Common RAID Disk Data Format Specification 1.2 Errata

Revision A

This document contains errata to the Common RAID Disk Data Specification Version 1.2.

Section 4.2.16

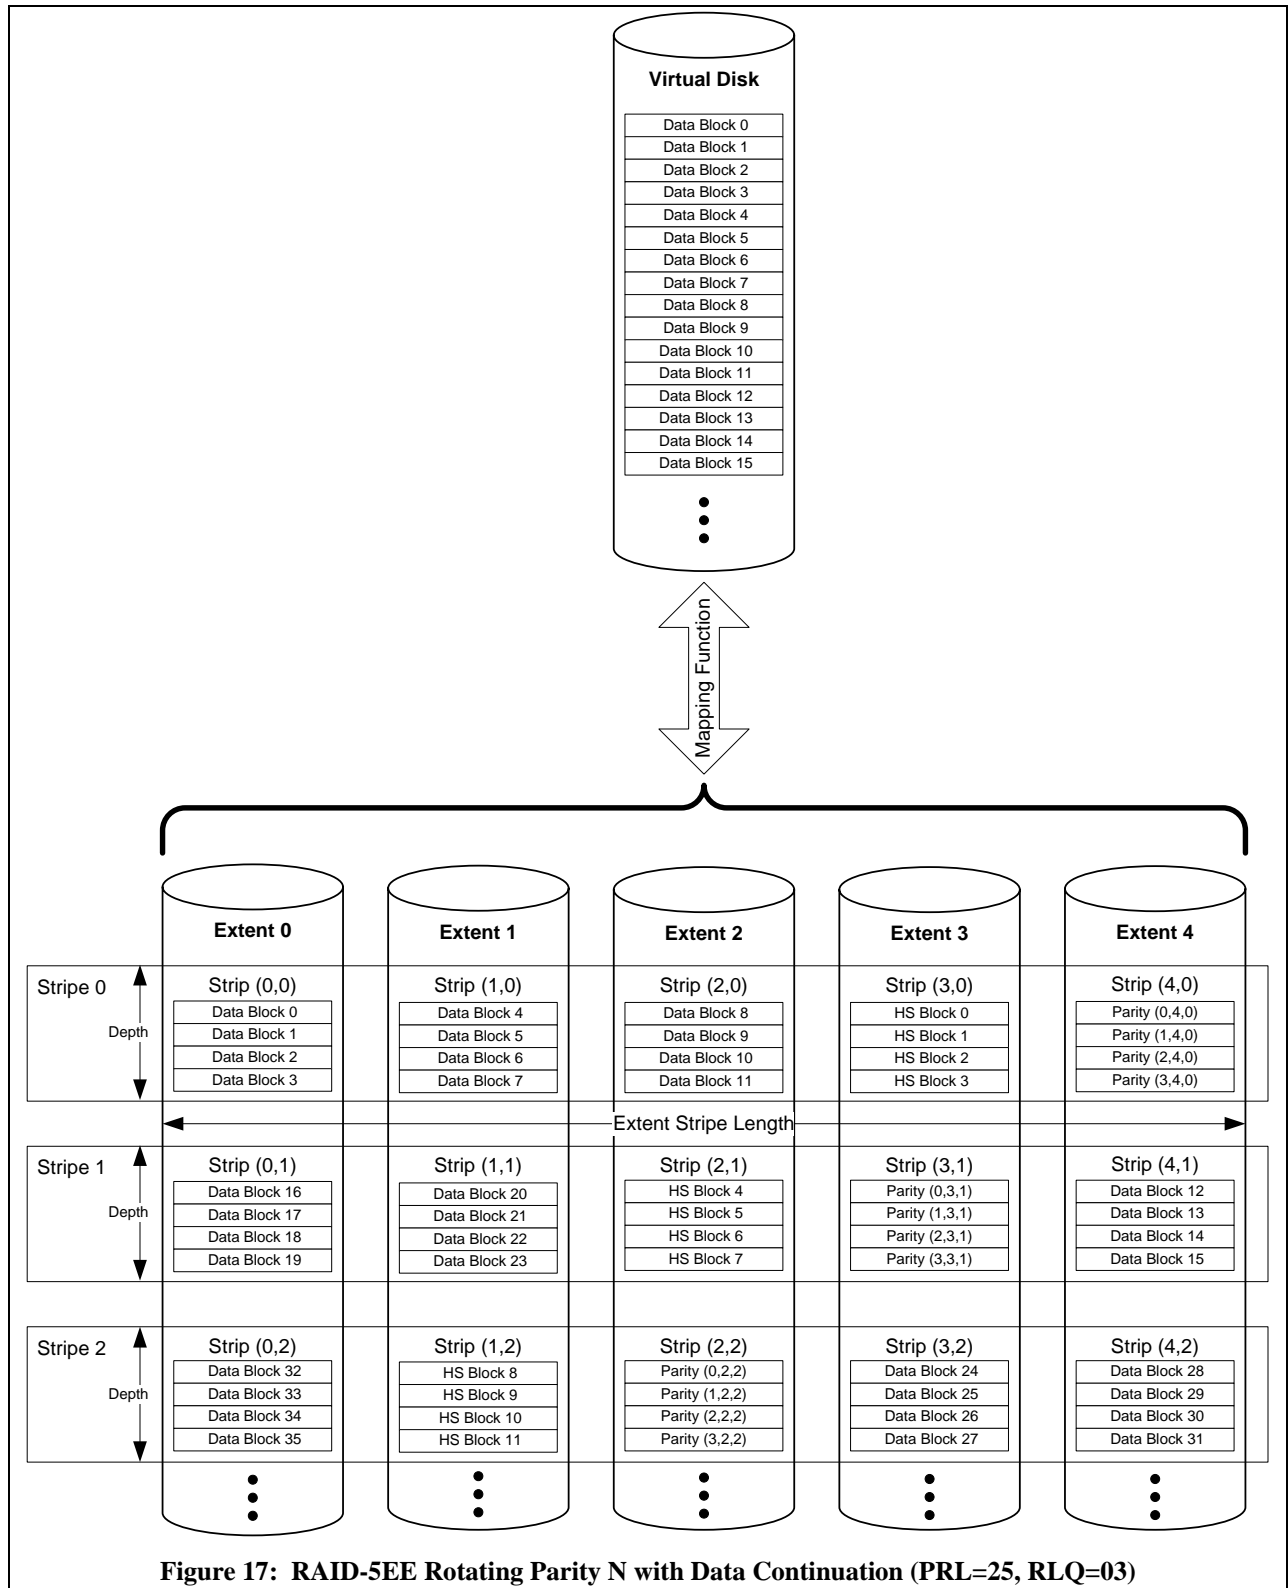
Figure 17 is incorrect. The figure will be replaced with the following figure:
